ADDENDUM NO. 3

Project: City of Whitefish Wastewater Treatment Plant Improvements Project - 2019

Date of Addendum: October 23, 2019

Sheet
C1-1

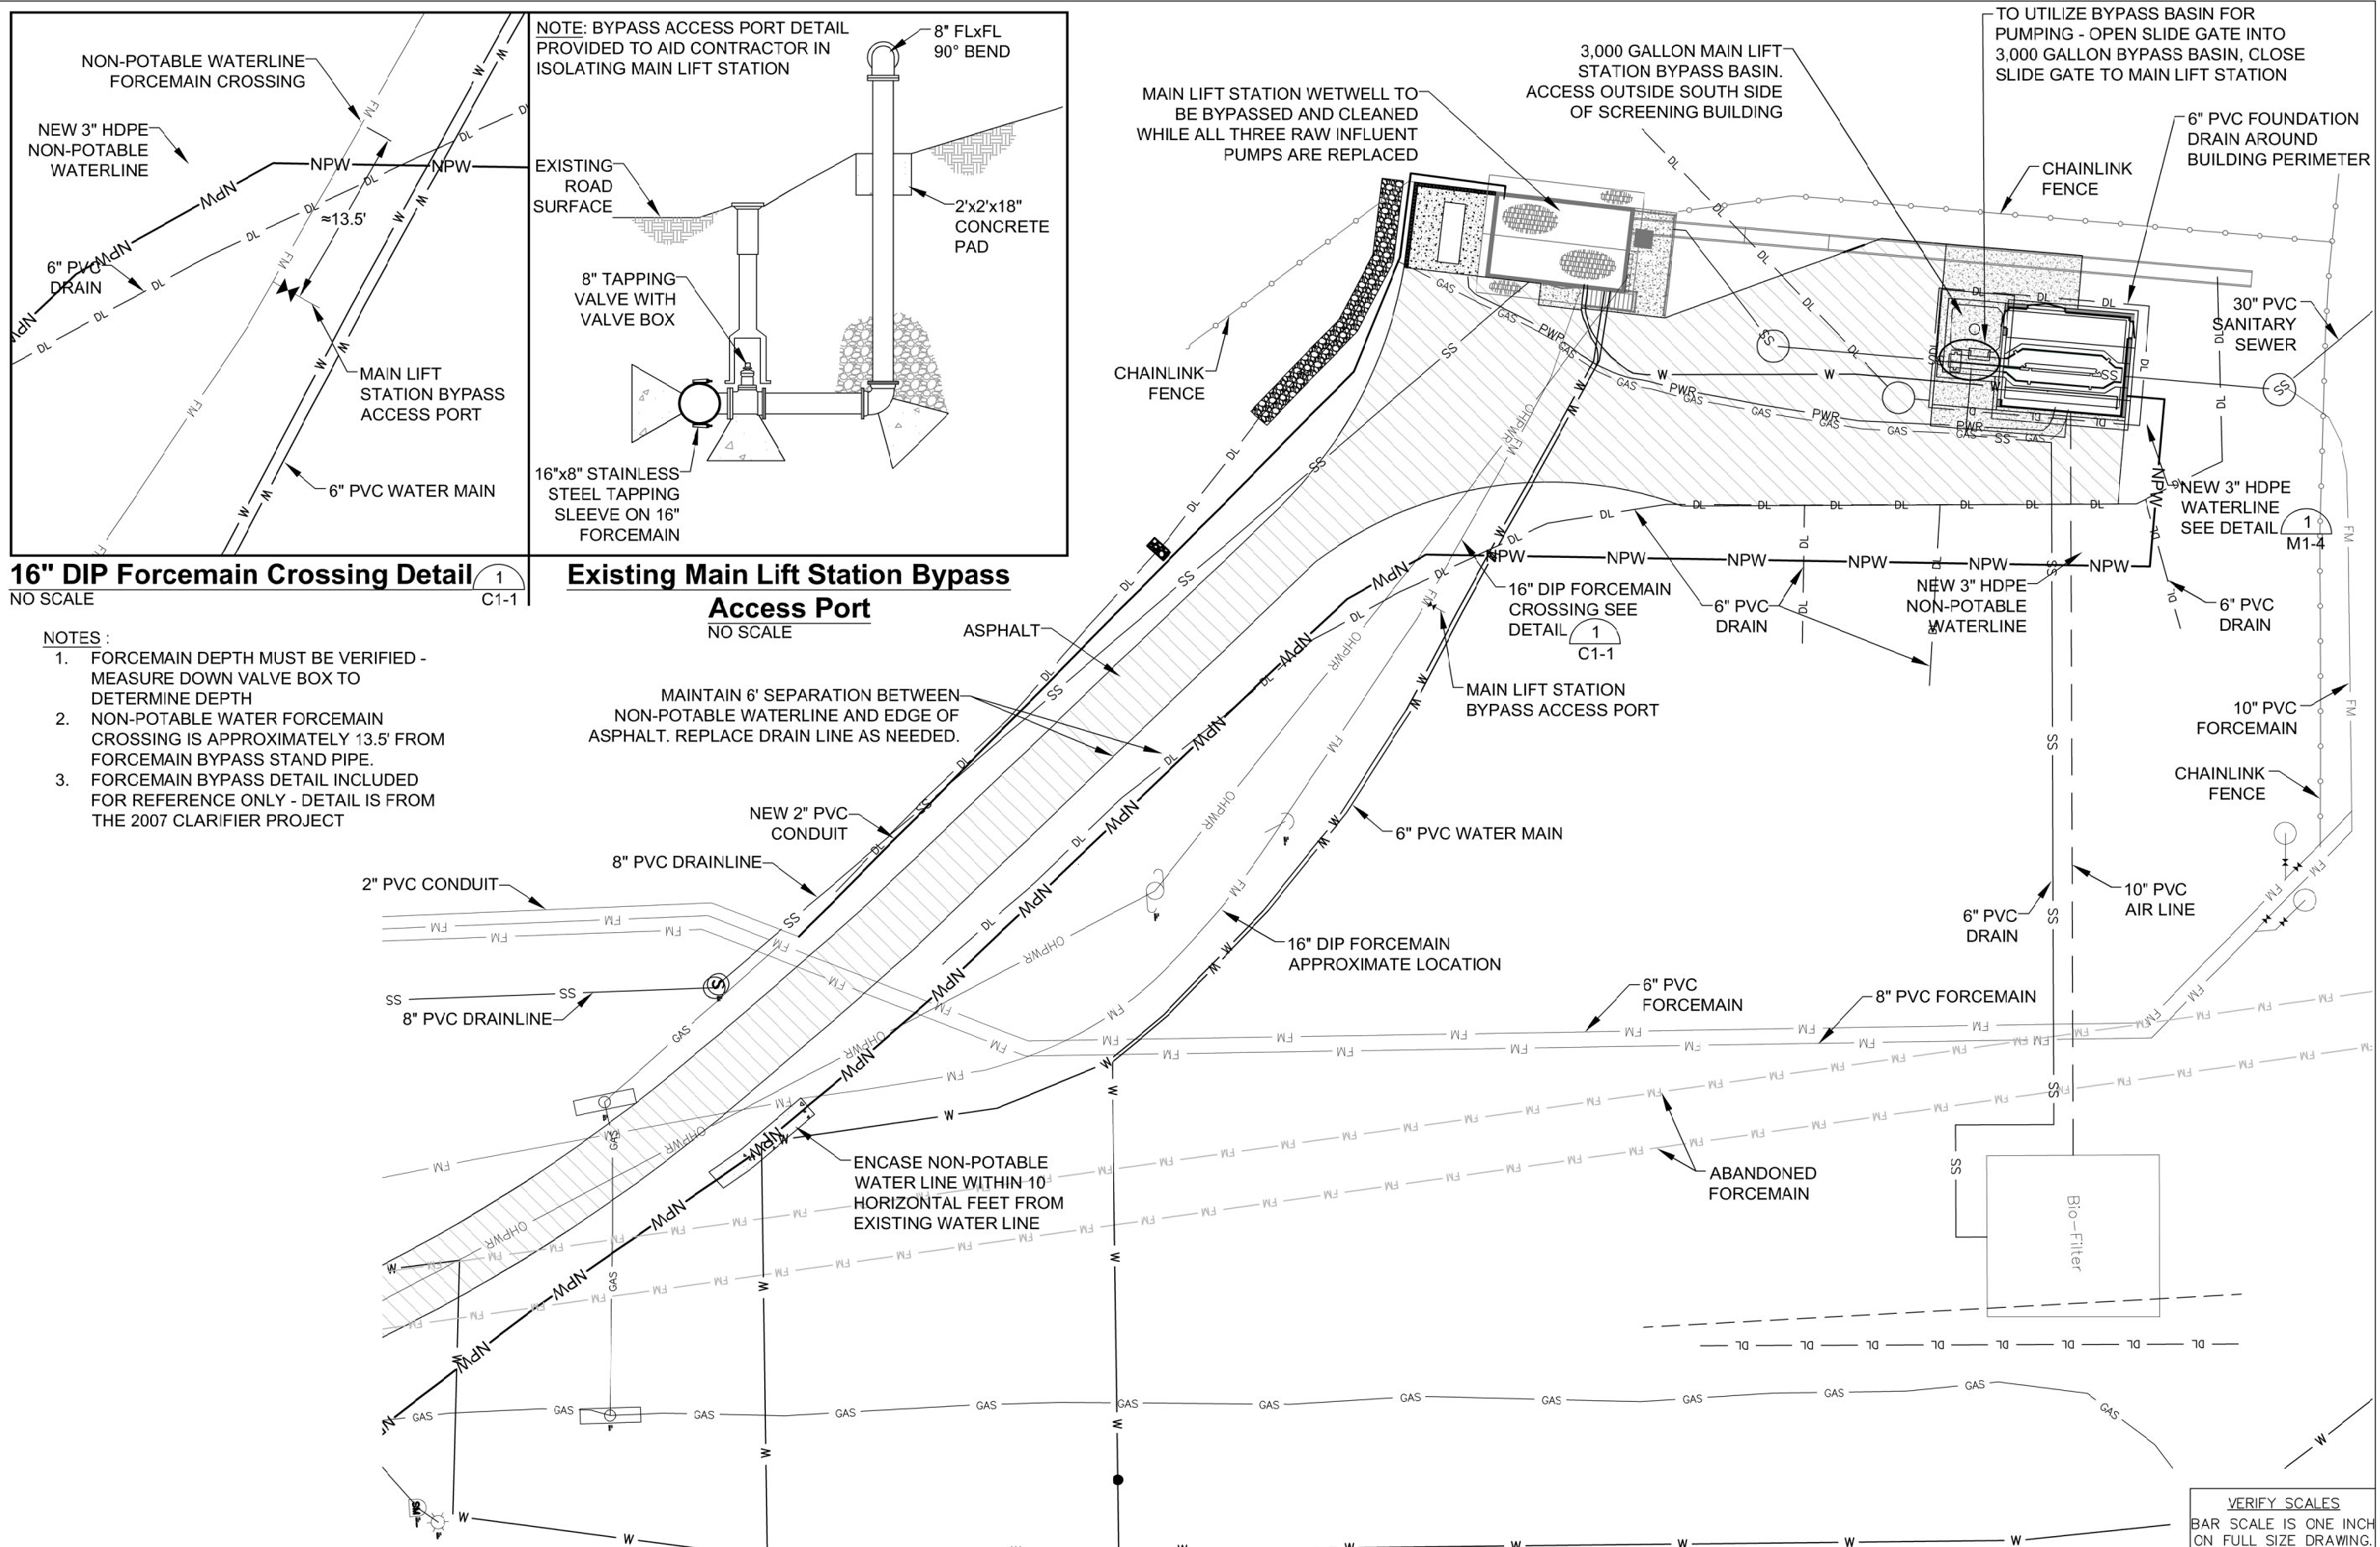
The 3" HDPE NPW pipe shall be encased in flowable fill where installed within 10' horizontal of the existing potable water pipe. Revised Sheet C1-1 is attached.

ENCASE NON-POTABLE WATER LINE WITHIN 10' HORIZONTAL FEET FROM EXISTING WATER LINE

Sheet
C6-3

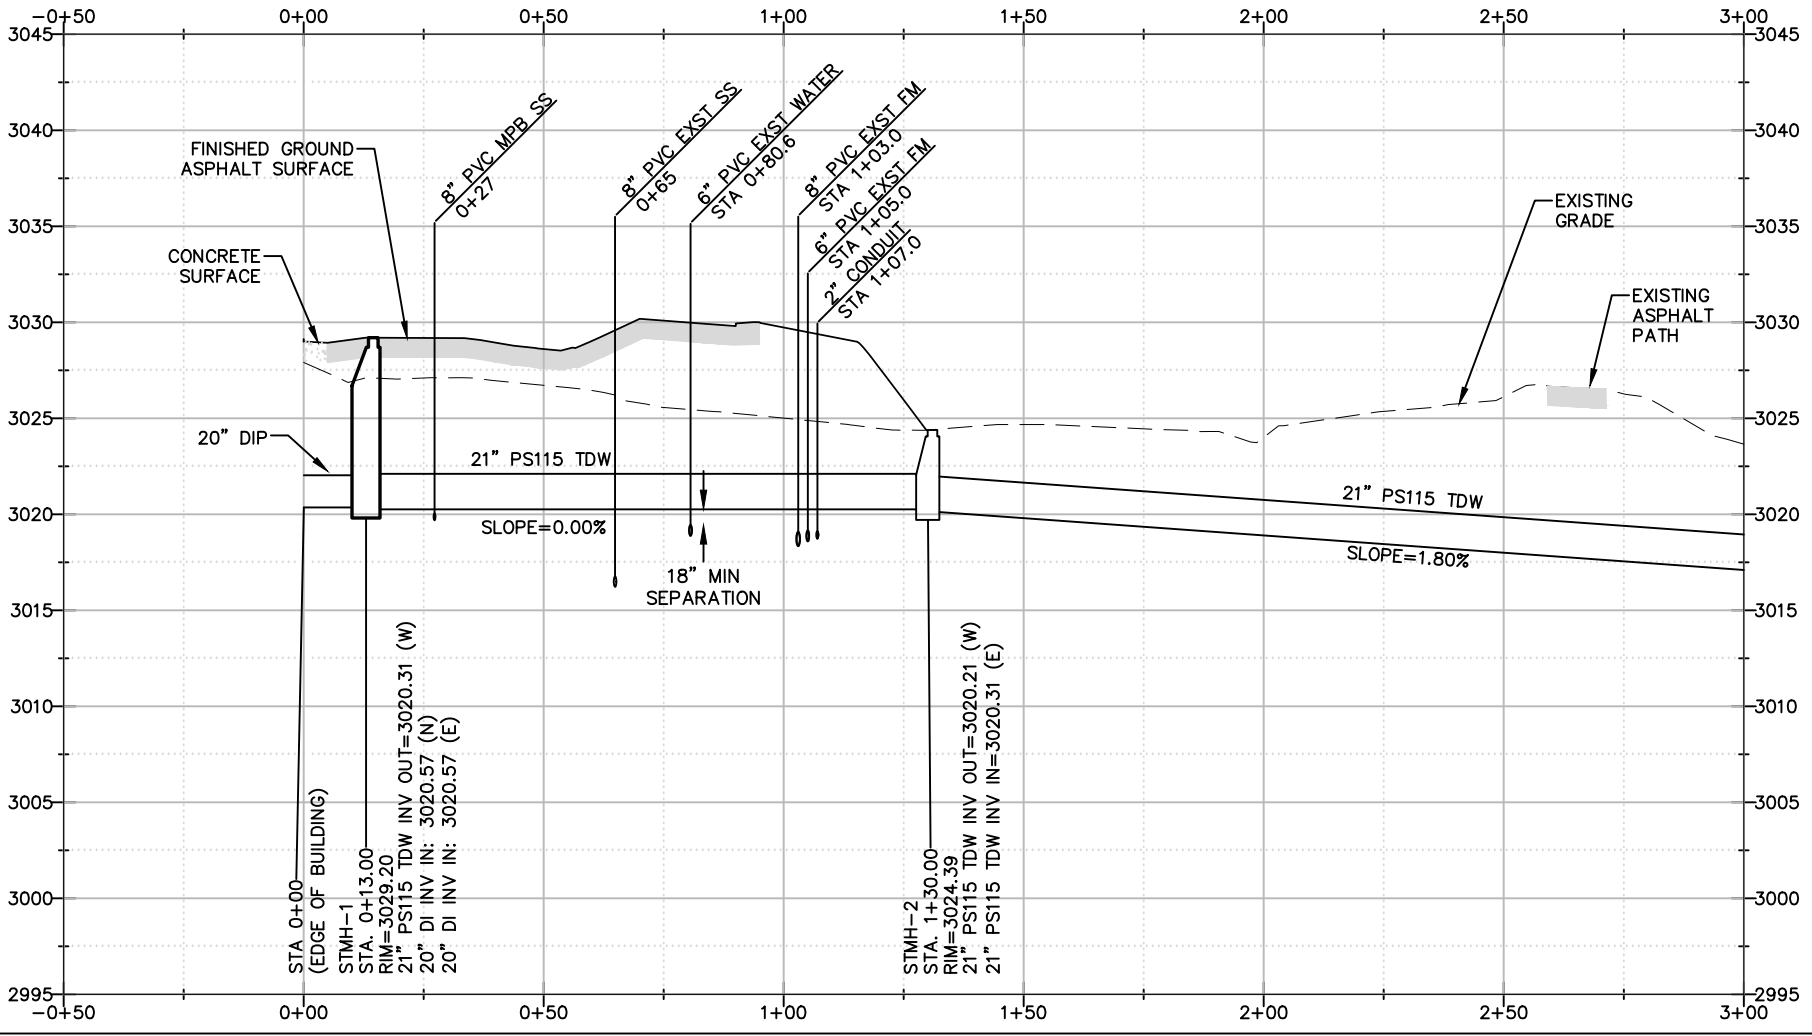
The 21" SDR26 PVC TDW pipe identified is herein changed to 21" PS115 PVC. Revised Sheet C6-3 is attached.

Sheet
C6-4

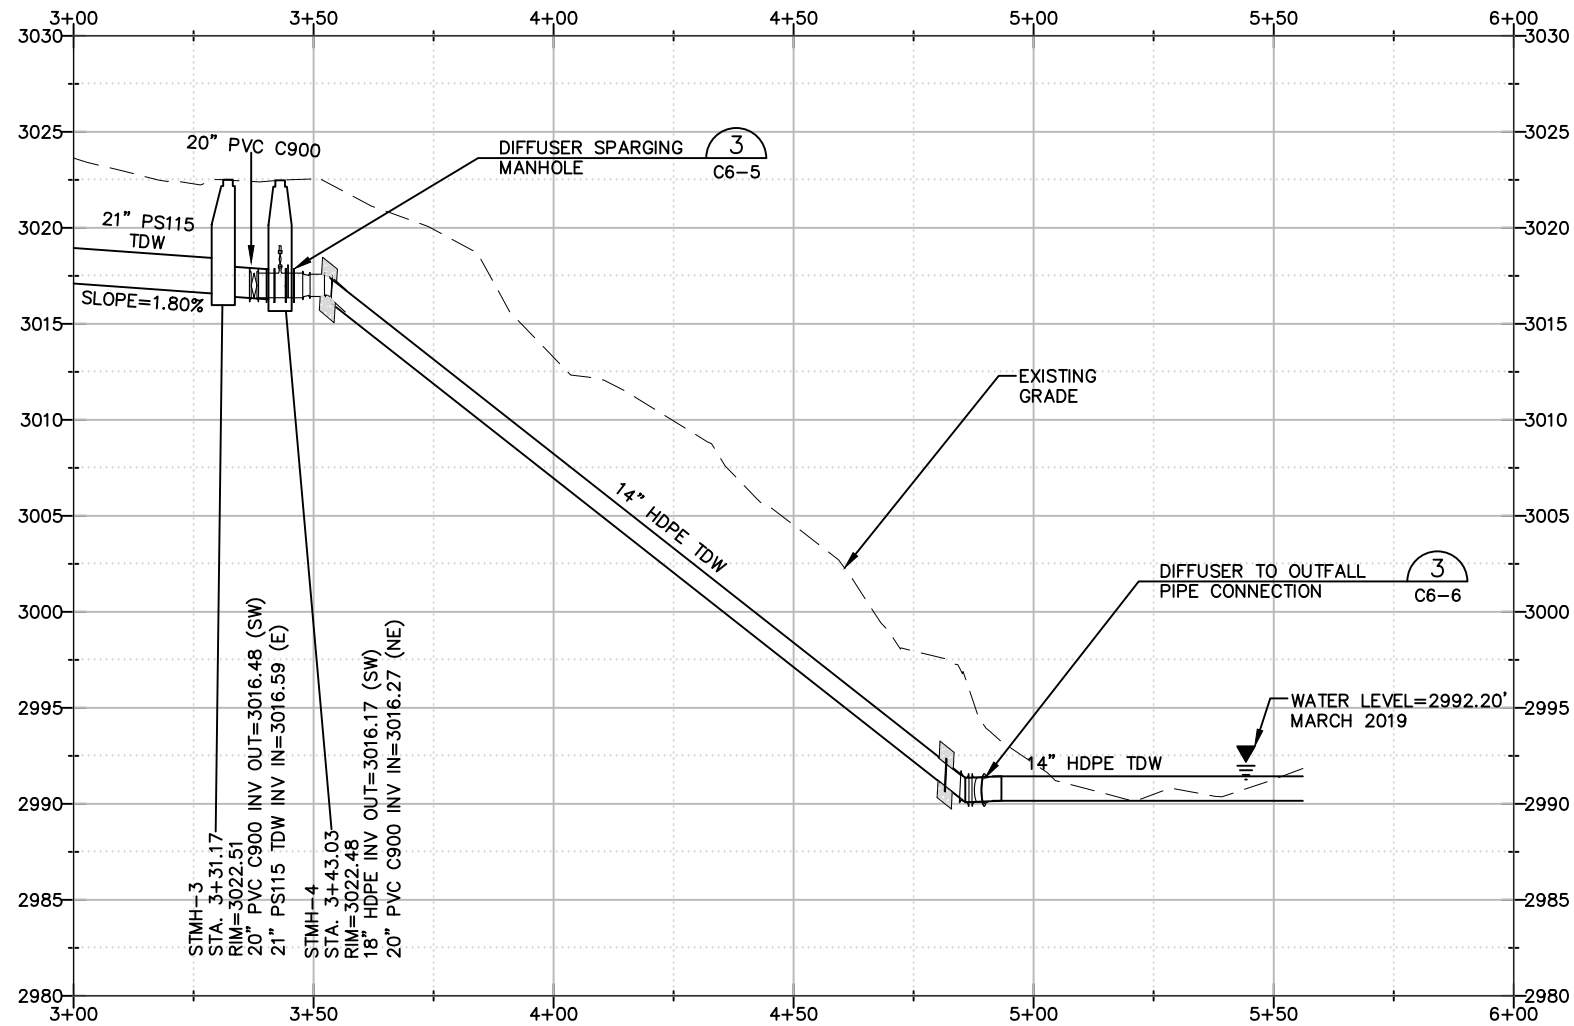
The 21" SDR26 PVC TDW pipe identified is herein changed to 21" PS115 PVC. Also, the 14" HDPE is DR 17. Revised Sheet C6-4 is attached.

Sheet
A8-1

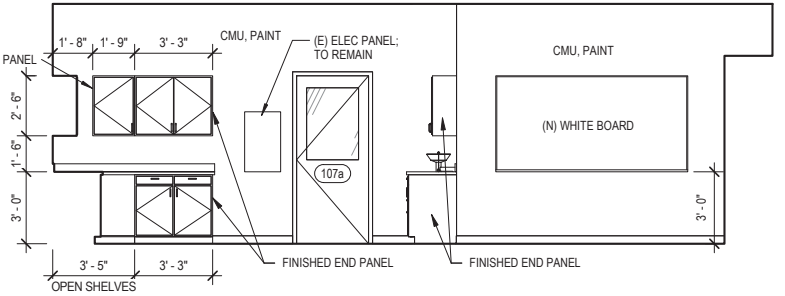
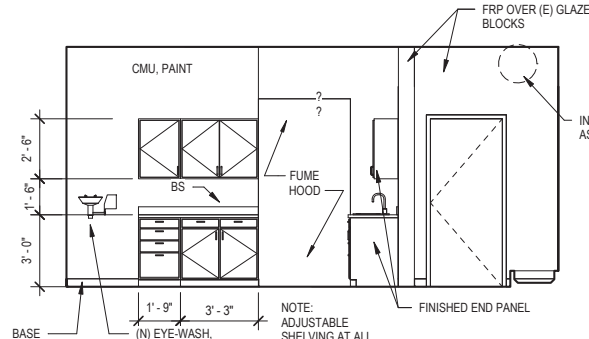
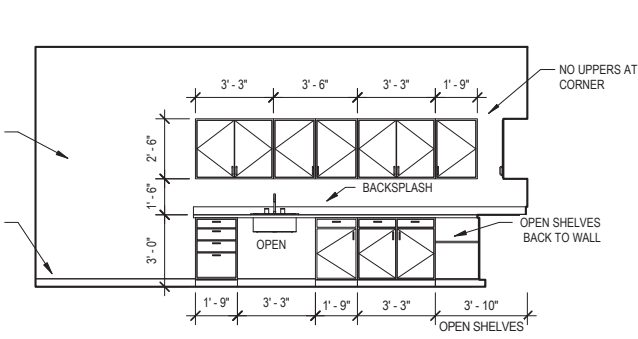
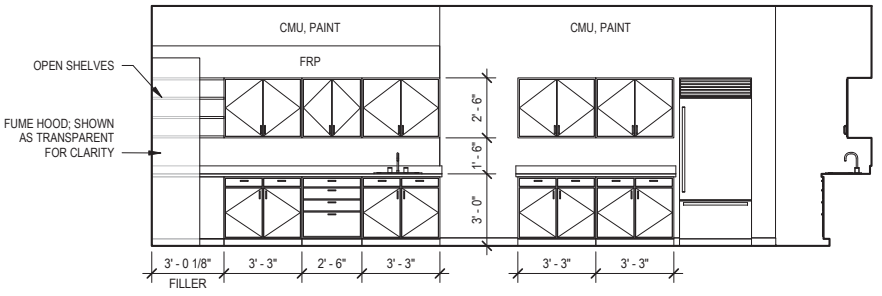
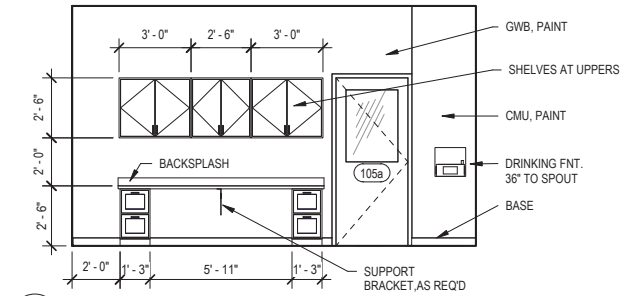
Details 1, 2, 3 and 4: Change all images of the wall-mounted toilets **to floor-mounted** toilets. Floor-mounted toilets comport with the mechanical drawings.

Room Finish Schedule: All bases, ceilings and walls in the: Electrical; U/V; Blower; Pump; Grit Wash and Grit Building Work Area shall be sealed concrete in accordance with Specification Section 09 90 00 – 2.07 and 2.08.
